Re: Dripline (Biergarten)
13202nd St NW
Traffic Circulation Layout
Engineer's/Architect's Stamp 06-14-2019 (J14D046)

Based upon the information provided in your submittal received 07-26-2019, the above referenced plan cannot be approved for Building Permit until the following comments are addressed:

TRAFFIC CIRCULATION LAYOUT PLAN

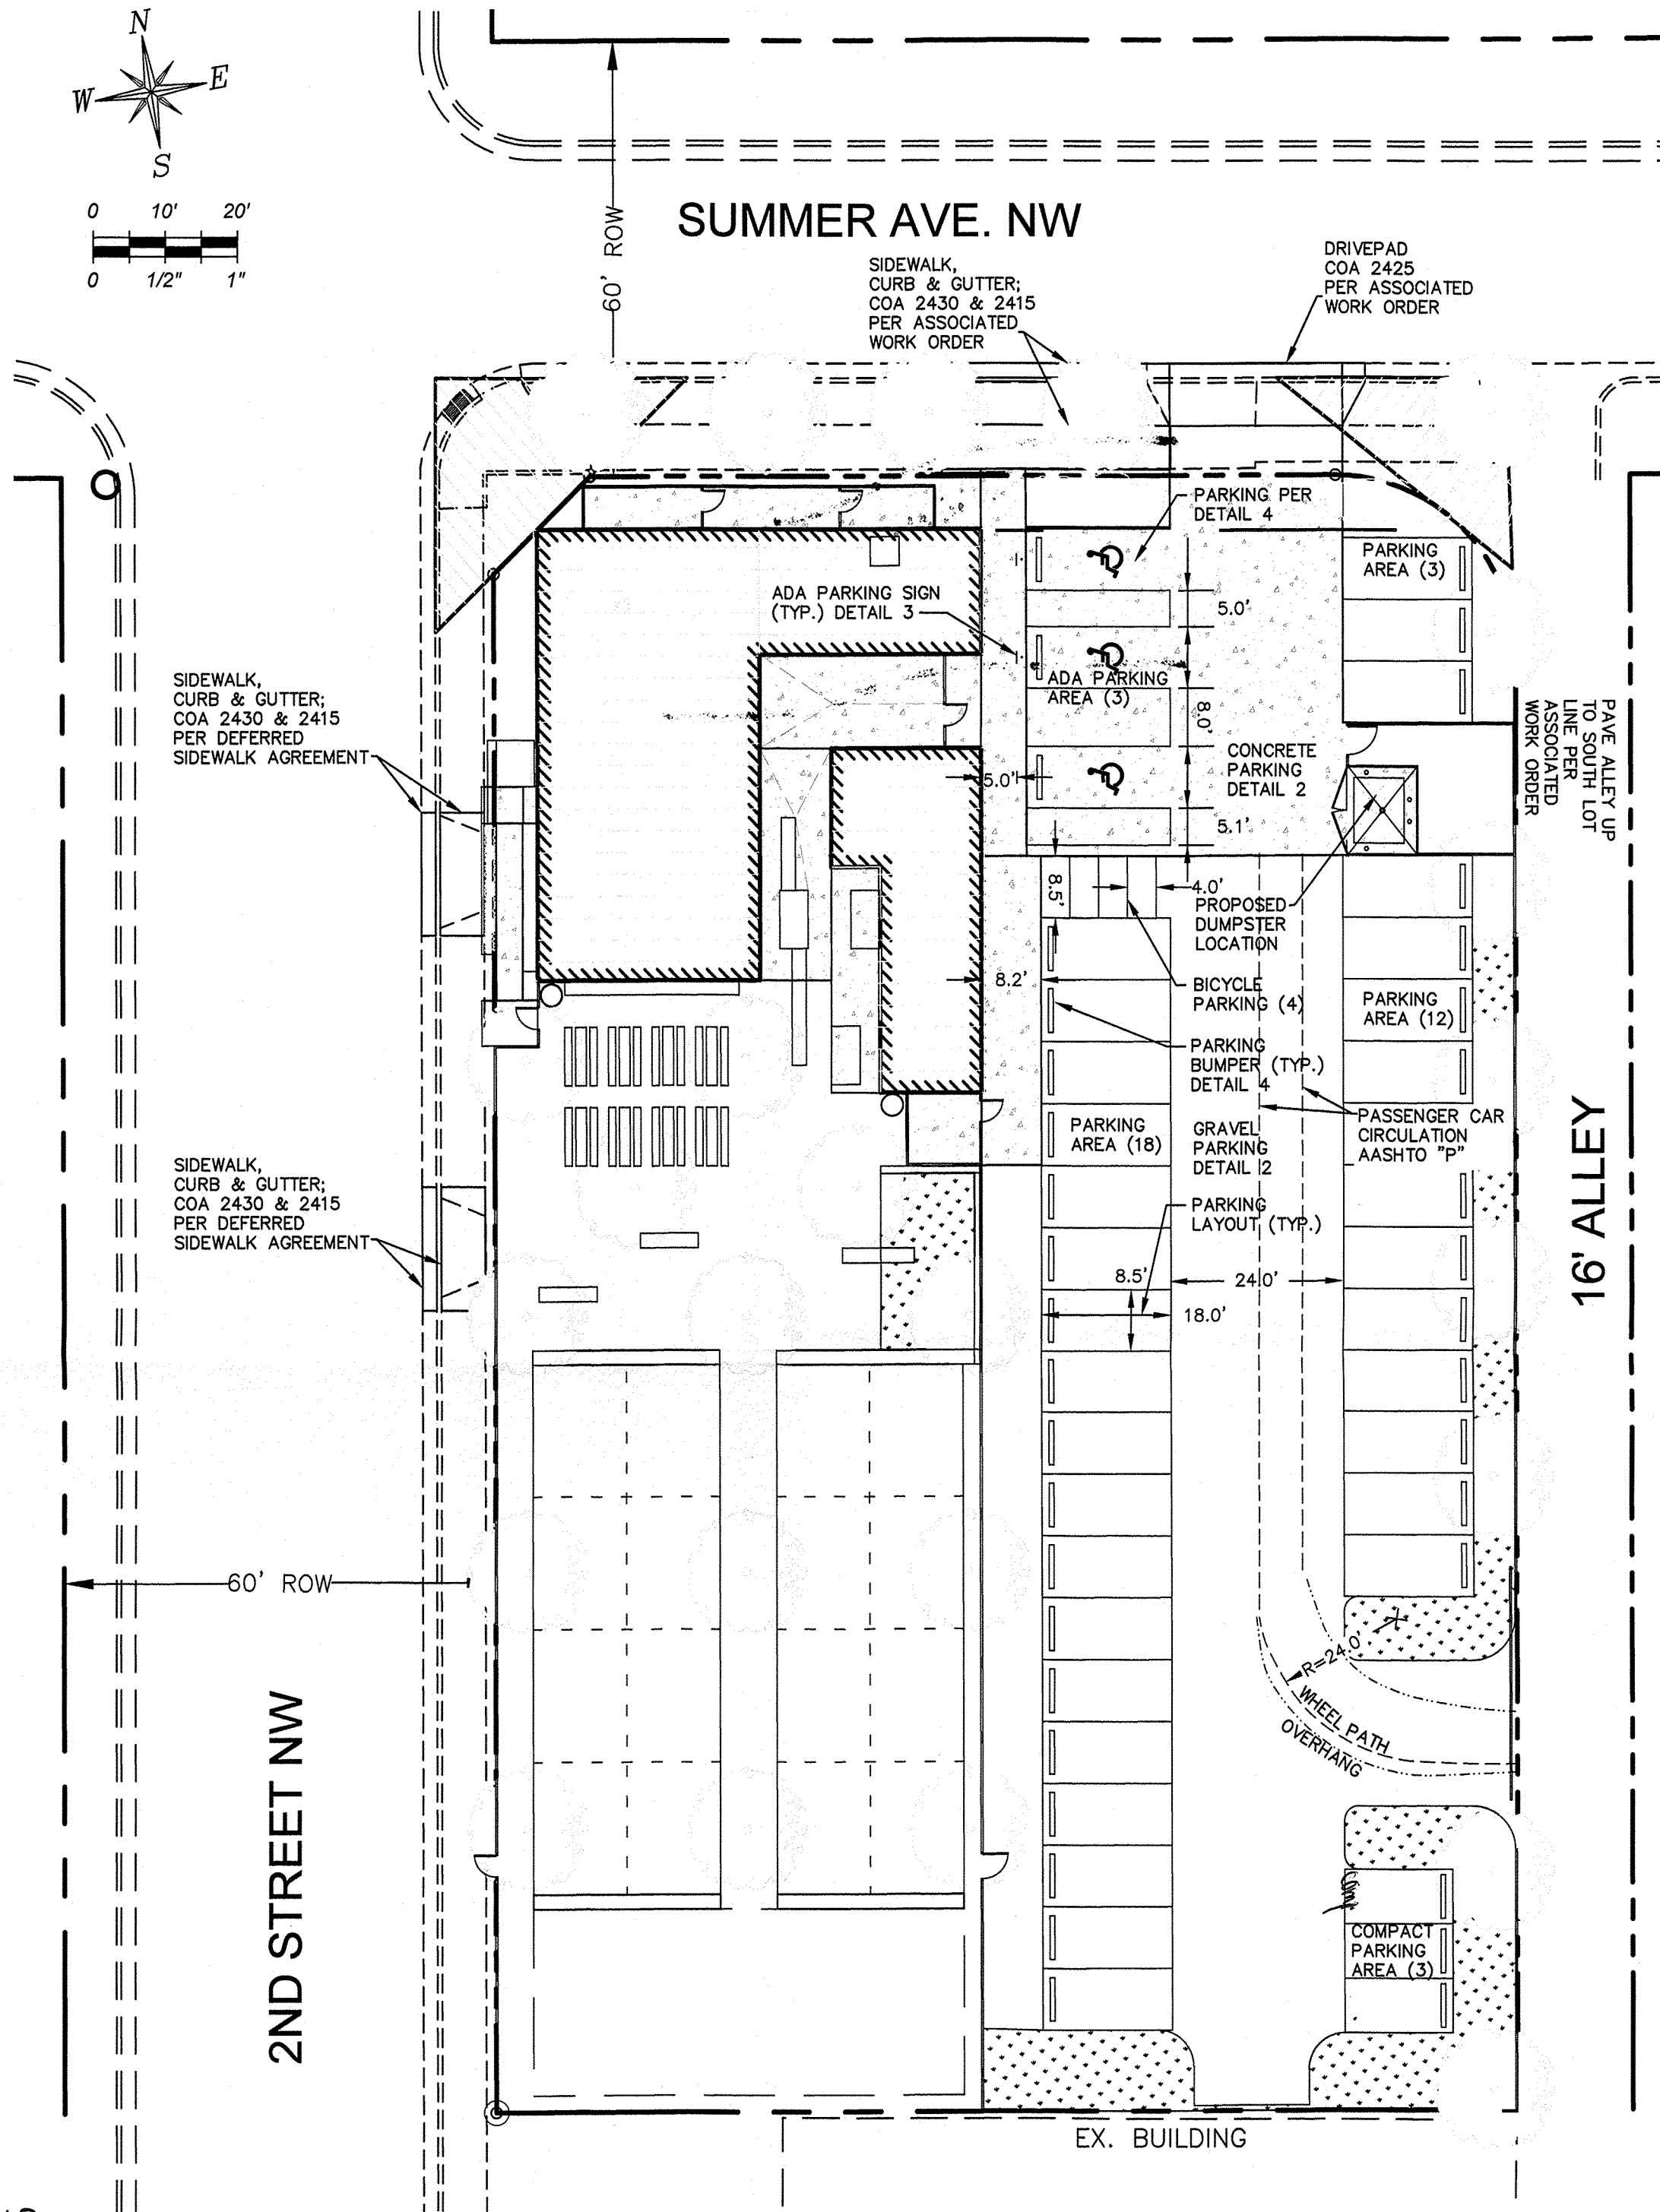
1. The parking calculation table:
 - a. 17 shared and 27 shared : please clarify what buildings are sharing these parking spaces and explain how this shared parking is acceptable.

- b. For designated spaces such as car pool, those spaces needs to have signs their own signs and be designated.
 - c. Label the compact parking spaces by placing the words "**COMPACT**" on the pavement of each space.

2. Bicycle comments from last time haven't been met:
 - a. All bicycle racks shall be designed according to the following guidelines:
 - i. The rack shall be a minimum 30 inches tall and 18 inches wide.

- ii. The bicycle frame shall be supported horizontally at two or more places. Comb/toaster racks are not allowed.
 - iii. The rack shall be designed to support the bicycle in an upright position. See the IDO for additional information.

- iv. The rack allows varying bicycle frame sizes and styles to be attached.
 - v. The user is not required to lift the bicycle onto the bicycle rack.
 - vi. Each bicycle parking space is accessible without moving another bicycle.

- vii. Bicycle racks shall be sturdy and anchored to a concrete pad.
- viii. A 1-foot clear zone around the bicycle parking stall shall be provided.
- ix. Bicycle parking spaces shall be at least 6 feet long and 2 feet wide.

- 3. provide a copy of refuse approval.
- 4. Remove trees or any type of landscaping from TCL.

- shared?
- label
- designate
